# MetroWest+

## Portishead Branch Line (MetroWest Phase 1)

**9.34 ExA.CWR.D5.V1 – Applicant's responses to Written Representations submitted for Deadline 4**

### Responses to submissions received at Deadline 4

The map below, extracted from appendix N part 2 Figure N-3, shows the 20 year return period event in 2015 tidal flood map also called the functional floodplain.

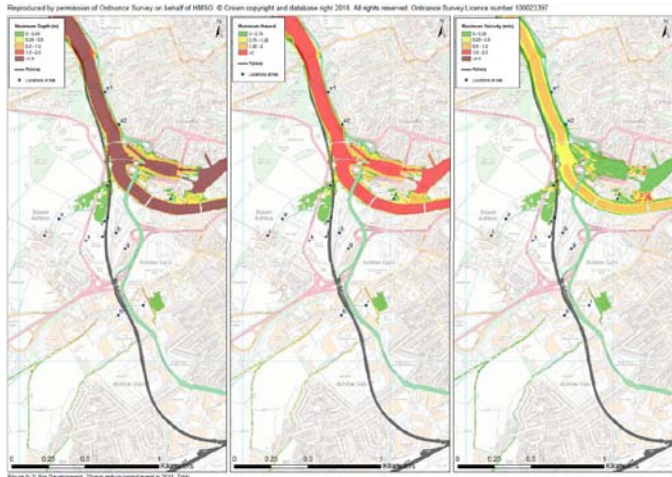
The map below, extracted from appendix N part 2 Figure N-3, shows the 20 year return period event in 2015 tidal flood map also called the functional floodplain.

Ref no.	Party	Response	Applicant's response
		 <p>The Agency has validated the applicant's model and considered the model fit for purpose. This means that the hydrology calculation has been verified and the model build has been confirmed, ensuring a standard approach has been used. The Agency also checked the model has been calibrated against a known event, which provides confidence that the model is able to represent reality. It is therefore, surprising to note the applicant now contends the model is over predicting flood risk.</p> <p>If it substantiated that the model is over predicting flood risk, further attempts must be made to calibrate the model to additional known events. Any such changes/ updates to the model will need to be detailed in a report, for the Agency's assessment.</p> <p>Further, if the model is over predicting, how accurate is the model at establishing floodplain compensation requirements, especially at Clanage Road? It is worrying to note the applicant's contention that the floodplain compensation provision at Clanage road is within model error.</p>
